ECE/TRANS/WP.29/2007/20  
8 December 2006

**AMENDMENTS TO THE PROPOSAL FOR 04 SERIES OF AMENDMENTS TO  
REGULATION No. 48**

(Installation of lighting and light-signalling devices)

Submitted by the representative of the European Community

Model A

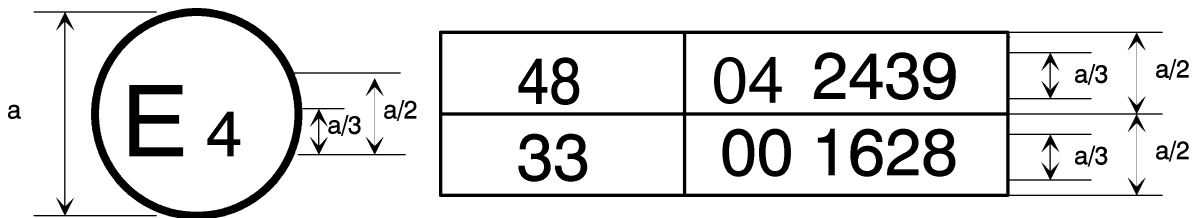
Annex 2, amend to read:

The above approval mark affixed to a vehicle shows that the vehicle type concerned has, with regard to the installation of lighting and light-signalling devices, been approved in the Netherlands (E4) pursuant to Regulation No. 48 as amended by the 04 series of amendments. The approval number indicates that the approval was granted in accordance with the requirements of Regulation No. 48 as amended by the 04 series of amendments.
